From: Hiser, Matthew
Sent: Wed, 31 May 2017 19:55:53 +0000
To: Frankl, Istvan
Subject: RE: Workshop Summary Report
Attachments: Harvesting Workshop Summary Report draft 5-26-17 (IF) mah incorp.docx

Ex-Plant Materials Harvesting Workshop Summary Report

Workshop held on March 7-8, 2017 at NRC headquarters in Rockville, MD

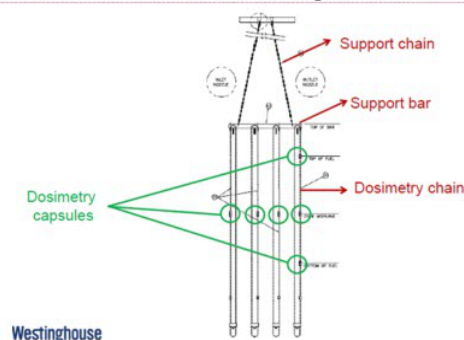
Commented [HA13]: Nice illustration, do you want to call it Figure 1 with a cross-referencw with the narrative?

Figure 1 Schematic of Westinghouse ex-vessel neutron dosimetry (EVND)

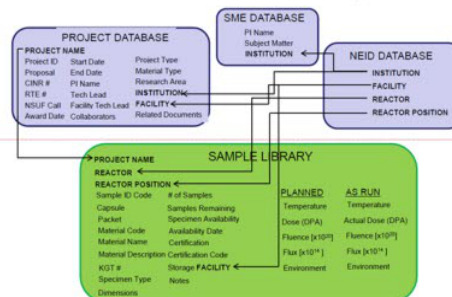
Commented [HA16]: Nice illustration, maybe cross-reference as Figure 2 with caption and call-out in text.

Figure 2 Nuclear Fuels and Materials Library (NFML) Database Design
